Docket Item # 9
BAR CASE # 2009-0083

BAR Meeting
May 20, 2009

ISSUE: Addition and Alterations
APPLICANT: Stephen Tanner (James McCrery AIA, Agent)
LOCATION: 220 South Lee Street
ZONE: RM / Residential

The applicant is requesting approval of a Certificate of Appropriateness to construct a basement level, one-story rear porch/deck addition, replace the existing front fence and make alterations at 220 South Lee Street.

South Lee Street
PROPOSED SITE PLAN

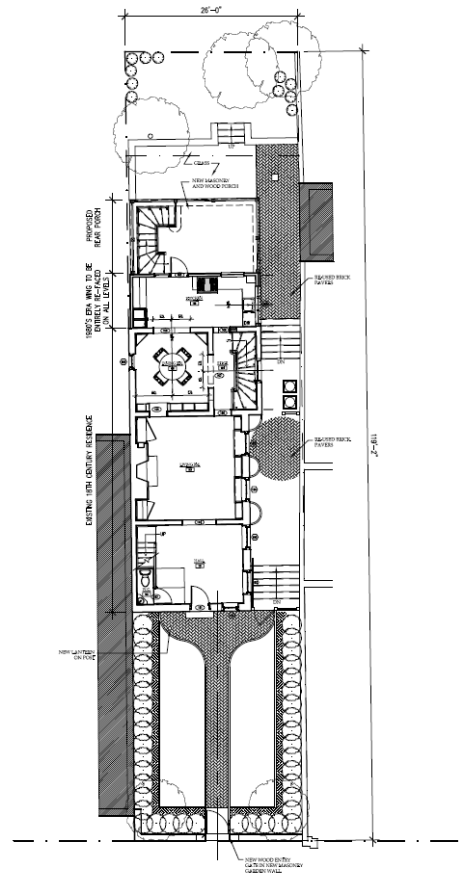
The zoning staff has noted that the current location of the A/C condenser units require that the adjacent property owners sign a waiver consenting to the placement of the units.

The applicant must ensure that the location of the fence is completely contained within the boundaries of their property, per zoning requirements.

1. That the applicant's are required to obtain the neighbor's written consent for the locating the units in their side yard, per zoning's requirements.

2. That the applicant will work with zoning staff to ensure that the placement of the brick fence is completely contained within their property boundaries, per zoning requirements.

PROPOSED WEST ELEVATION

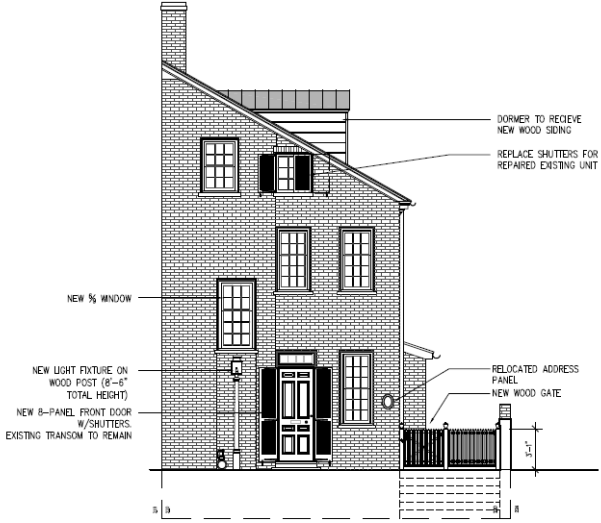
The proposed eight-panel front entry door is not as common on houses dating to the late 1700s and early 1800s. These doors are more typically found on houses that are in the Greek Revival style. It is recommended that a six-panel door would be a more appropriate replacement door for a house with Federal style influences.

3. That the style of the front door will be changed from the proposed solid wood 8-panel door to a more Federal style, solid wood 6-panel door.
4. The statements below are archaeology conditions and shall appear in the General Notes of all site plans and on all site plan sheets that involve demolition or ground disturbance (including Basement/Foundation Plans, Demolition, Erosion and Sediment Control, Grading, Landscaping, Utilities, and Sheeting and Shoring) so that on-site contractors are aware of the requirements.

PROPOSED EAST ELEVATION

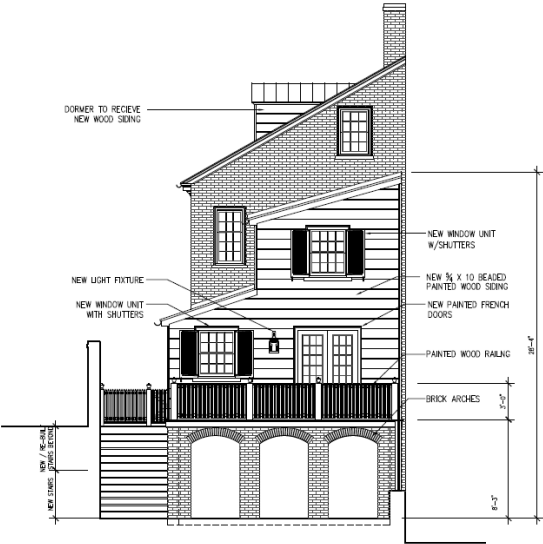
The specifications for this project do also include the installation of a double-insulated, wood, simulated-divided light French door on the rear elevation - the only simulated-divided light product proposed in the entire project. While single-glazed, true-divided-light wood windows and doors are preferable, the *Design Guidelines* and the Board generally supports double-pane,

insulated, simulated-divided-light wood windows and doors on modern additions or in areas with limited visibility, both of which apply in this case. Staff finds that the proposed door is appropriate, as this French door is to be installed on a 1980's addition and is to be located on the rear elevation of the structure.
